Carlyle/Eisenhower East Design Review Board (DRB) Application

PROJECT NAME: Carlyle Block P BLOCK: P

DESCRIBE THE REQUEST BRIEFLY: Approval to minor modifications to the previously approved design of the South Tower of Carlyle Block P.

765 JOHN CARLYLE - SOUTH TOWER

NORTHEAST VIEW OF SOUTH TOWER - PROPOSED AND PREVIOUS

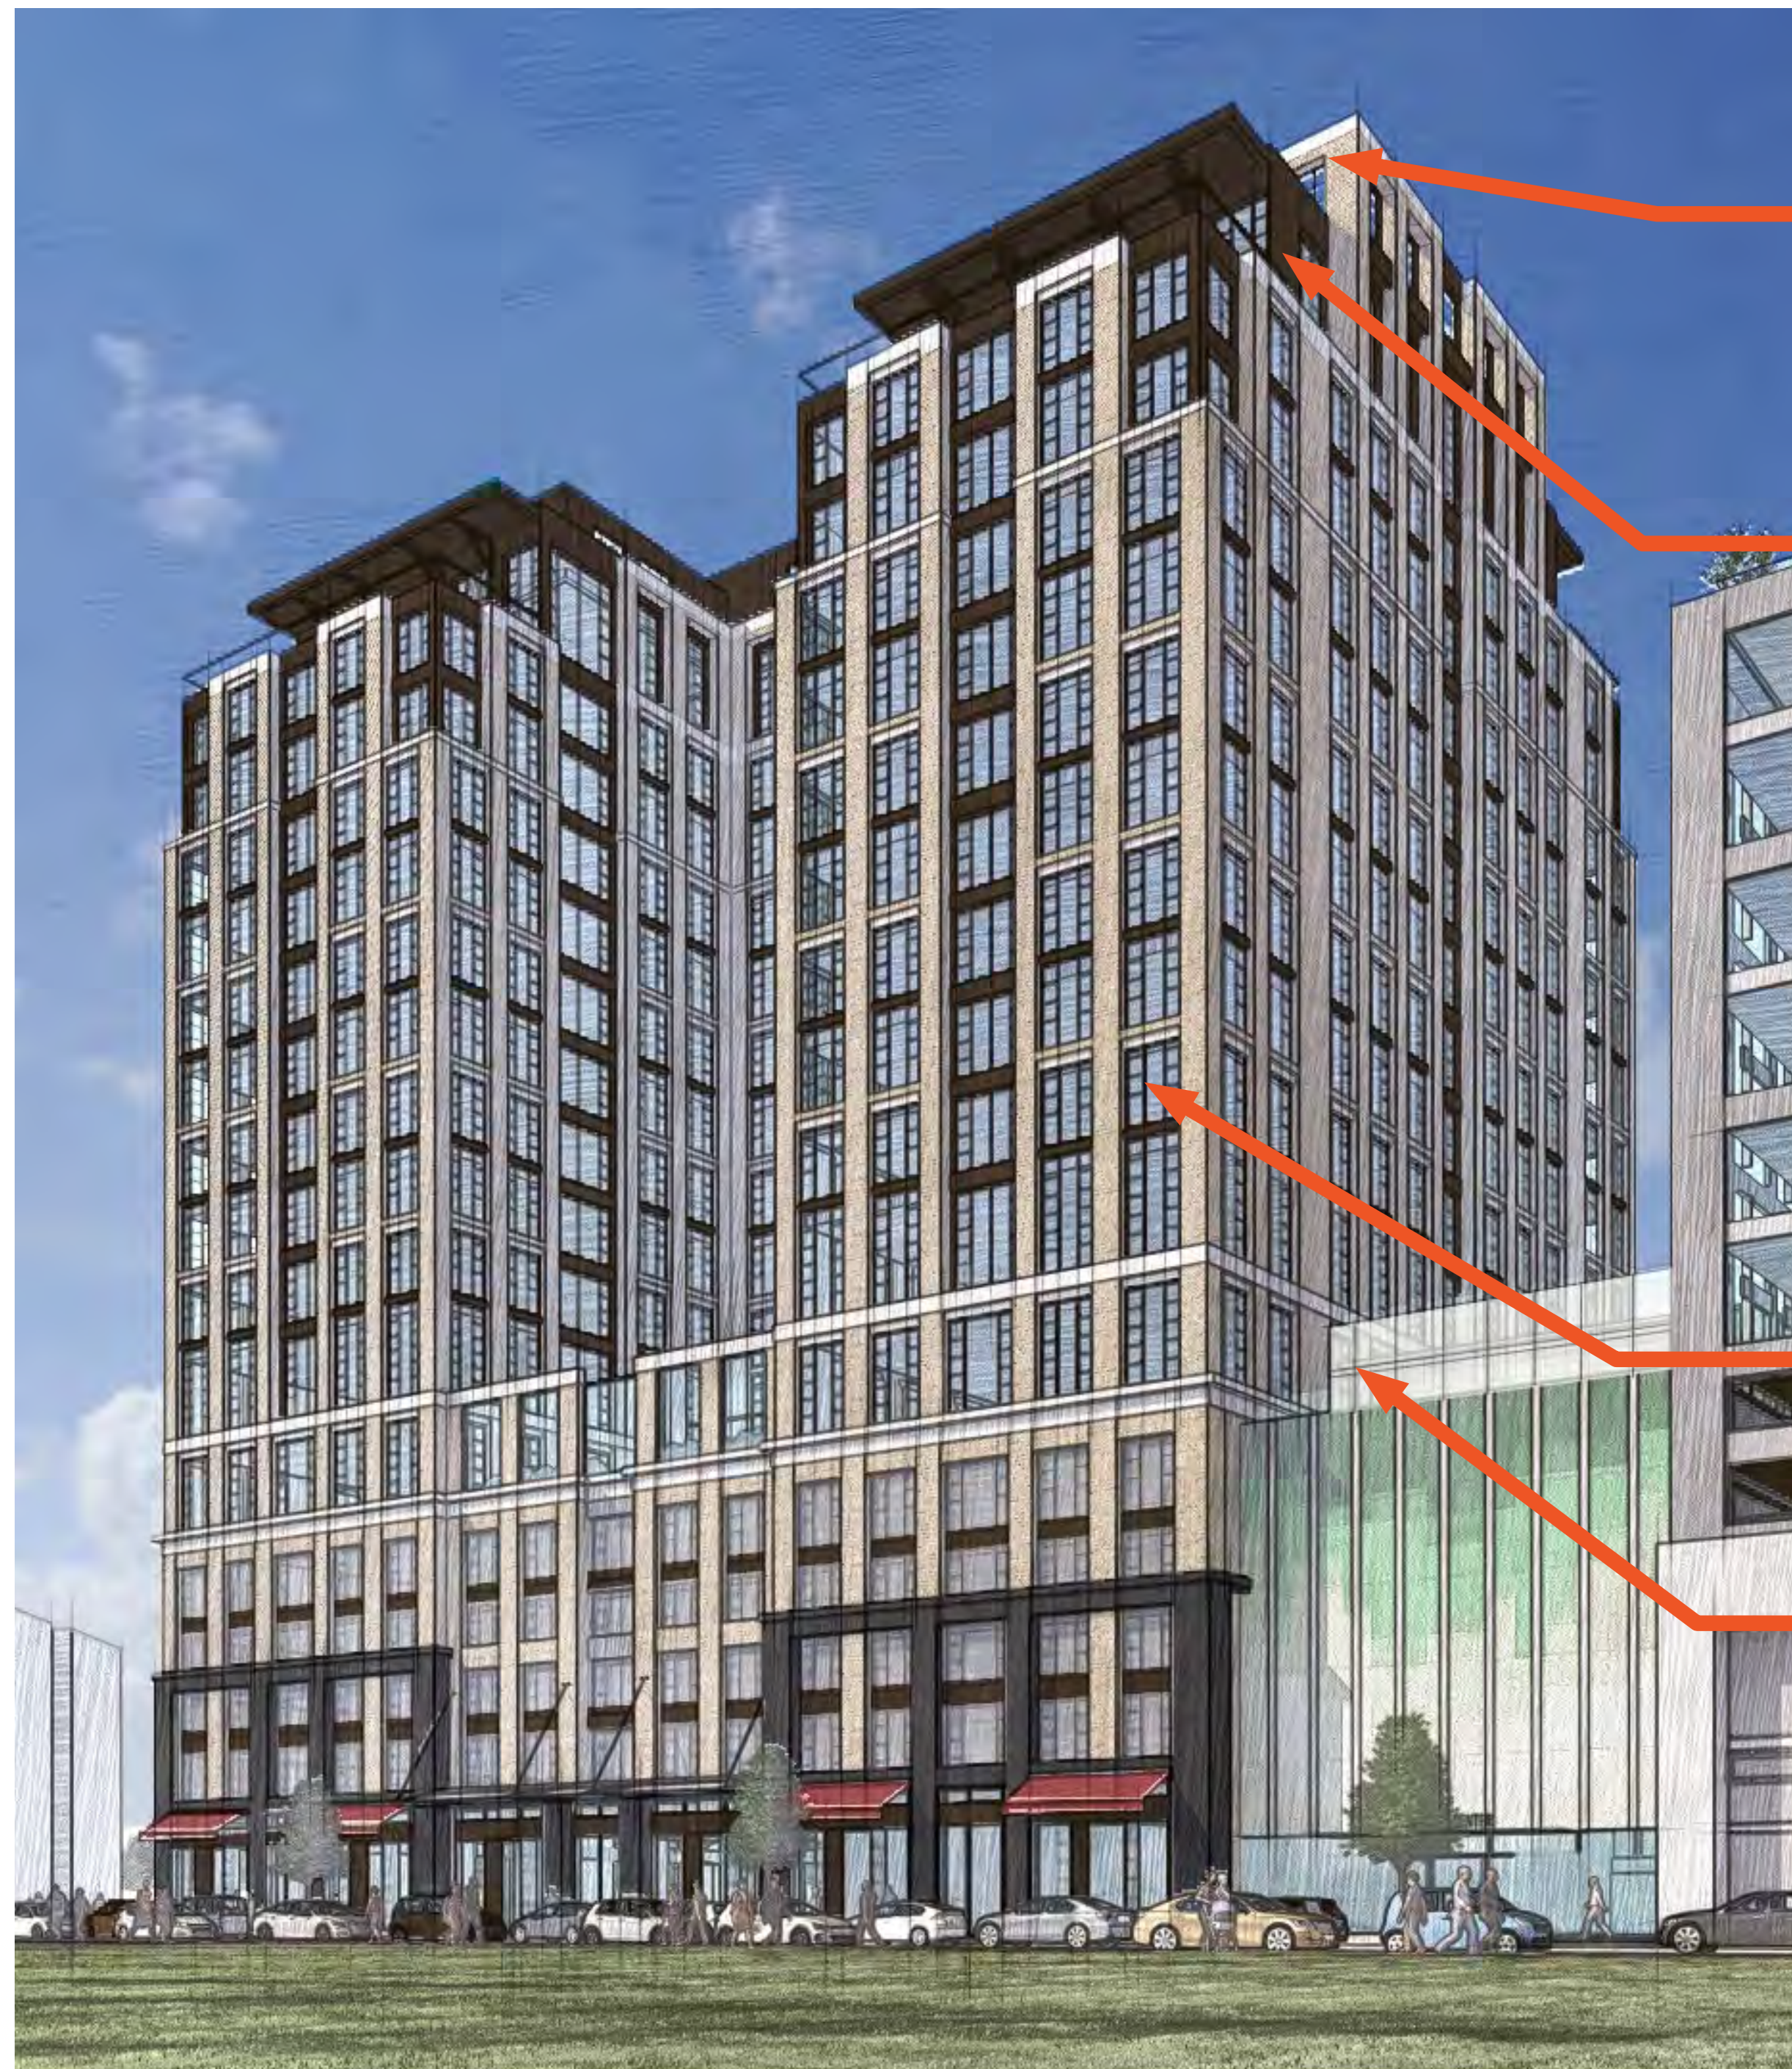
6 MECHANICAL YARD SCREEN ADJUSTMENTS

5 MATERIALS AT THE TOP OF THE BUILDING: DARK METAL VS DARK BRICK

4 ADDED FLOOR

3 CHANGED FLOOR HEIGHTS

2 WINDOW PATTERN: SECONDARY MULLIONS VS FEWER MULLIONS

1 EXTERIOR WALLS MOVED OUT FOR SENIOR LIVING AND MATERIALS CHANGED FROM GLASS TO GLASS AND LIGHT BRICK

PROPOSED 6TH FLOOR PLAN

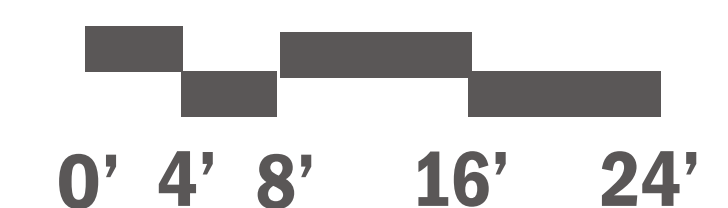
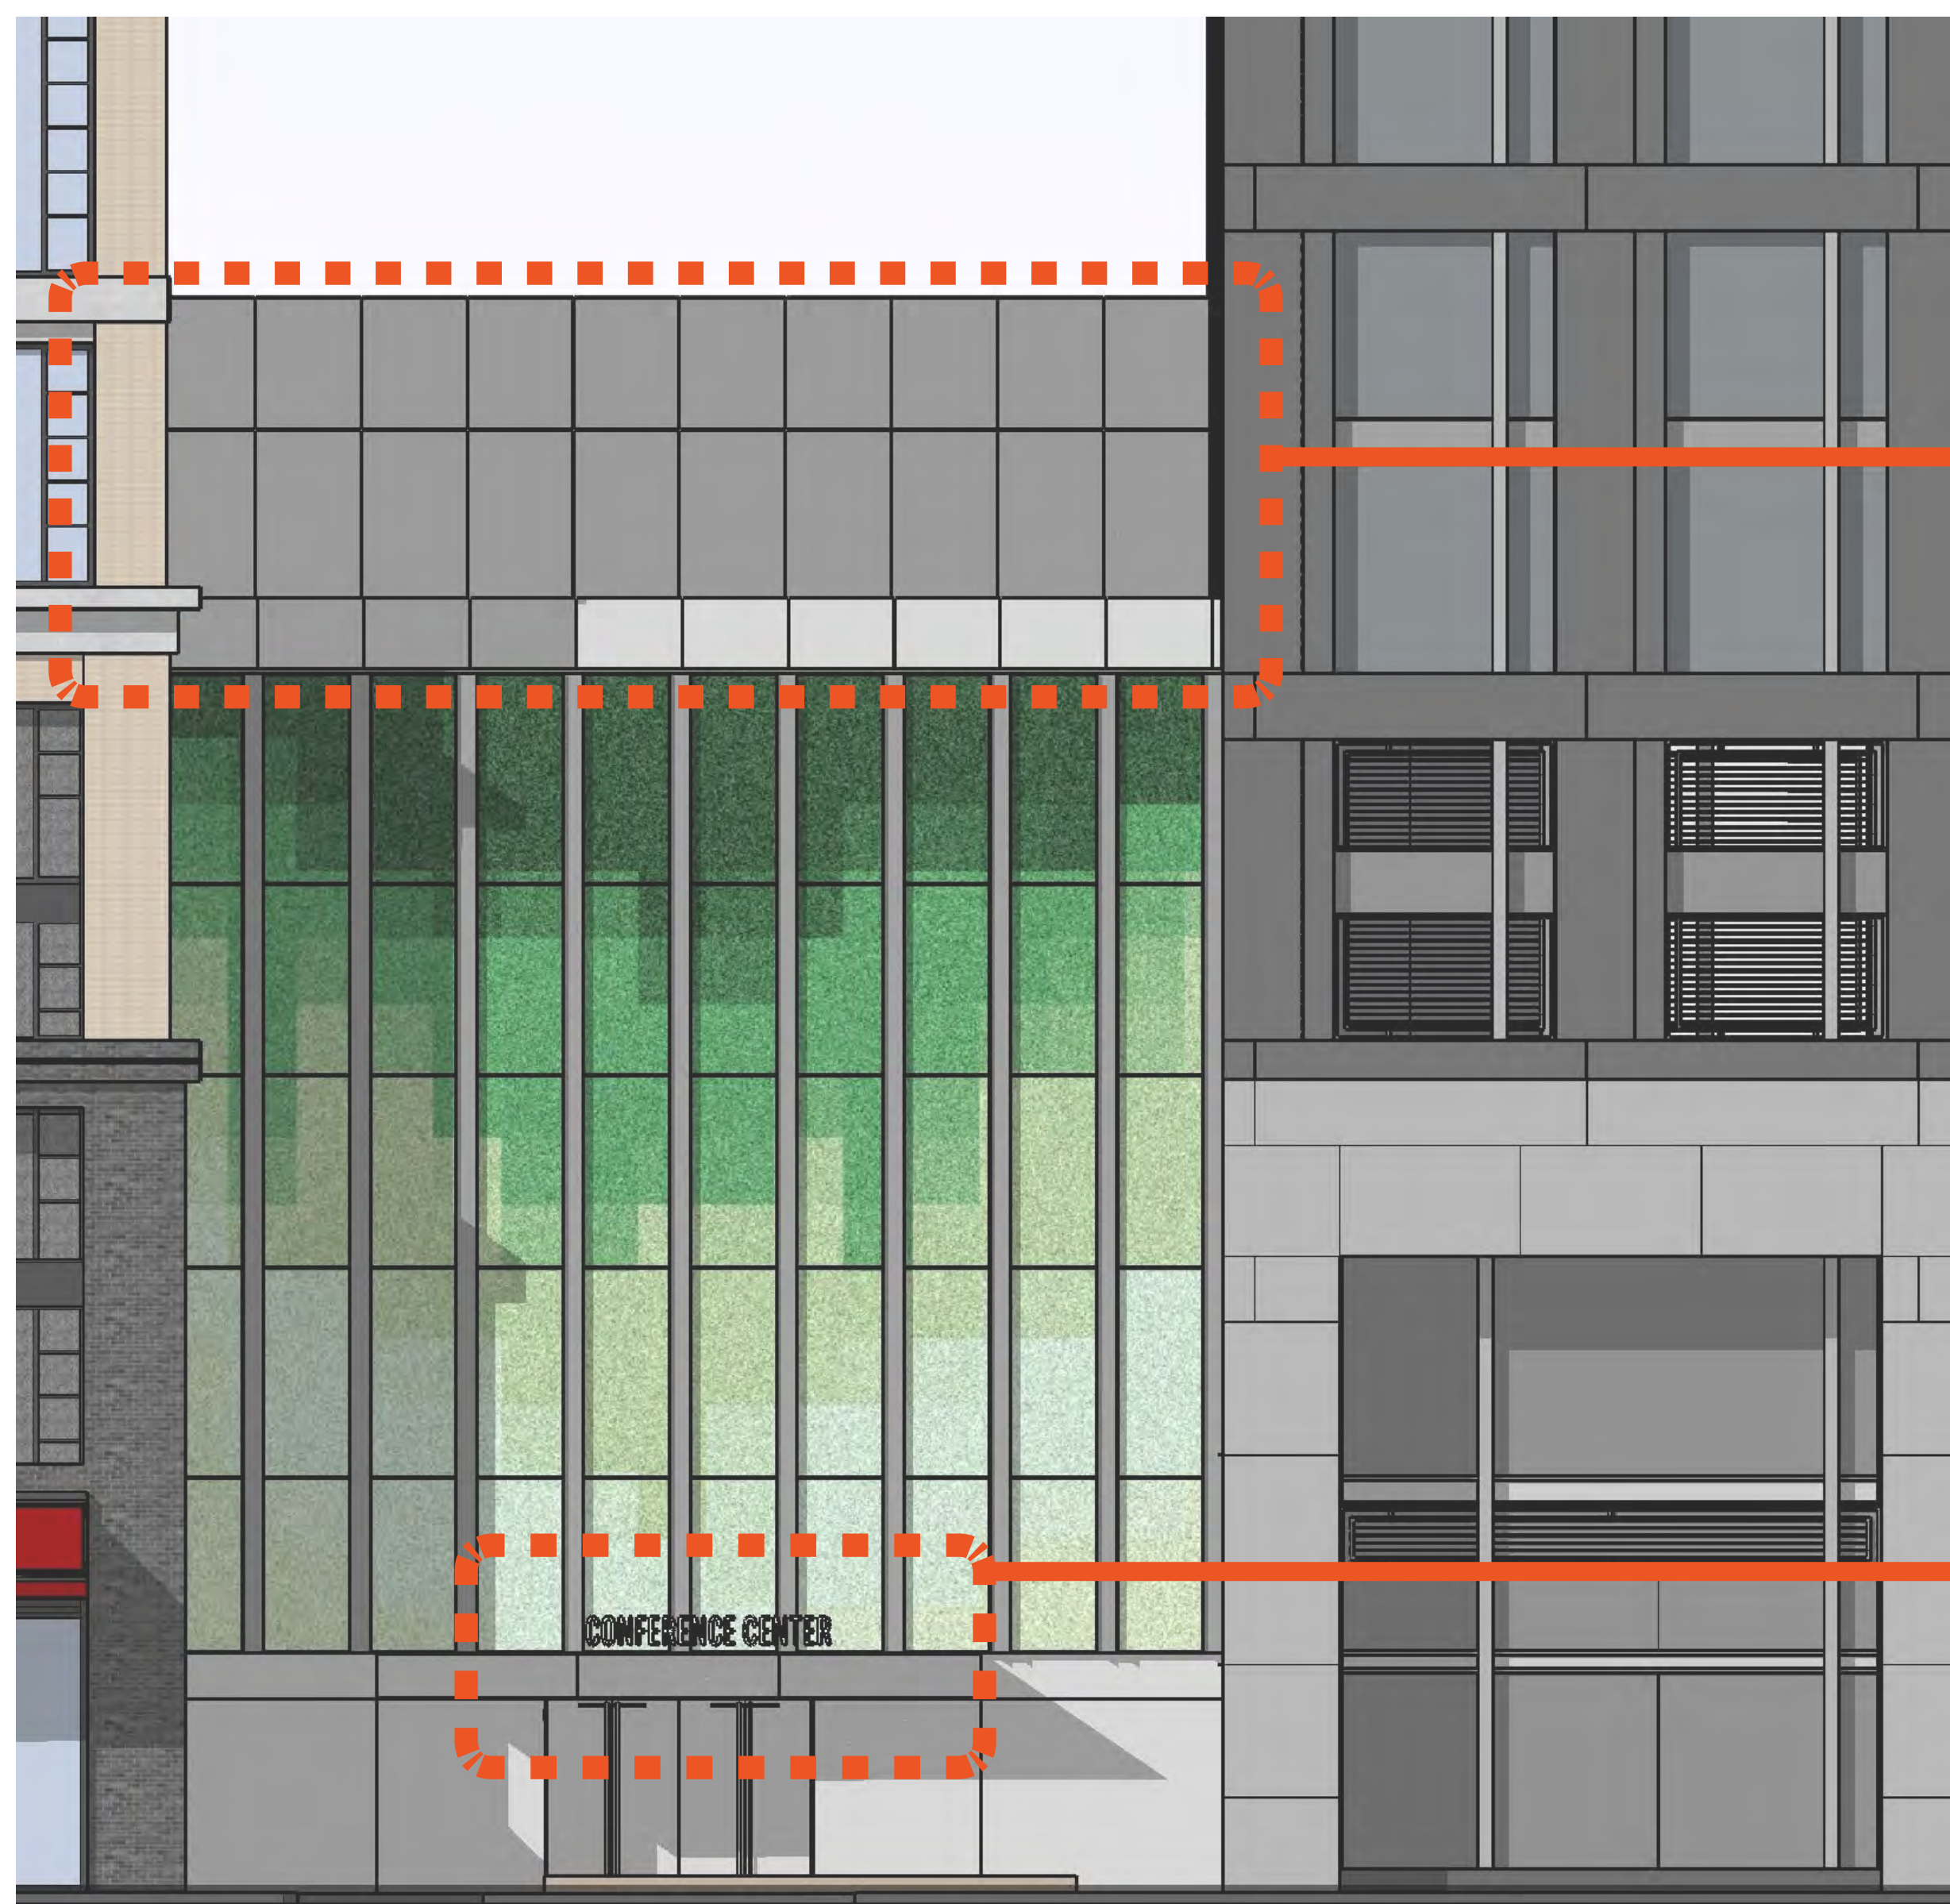
- Residential facade has solid elements to accommodate demising walls
- Planted terraces on 6th and 7th floors
- EAST/WEST facades on 6th level have been pushed outward to accommodate residential units inside
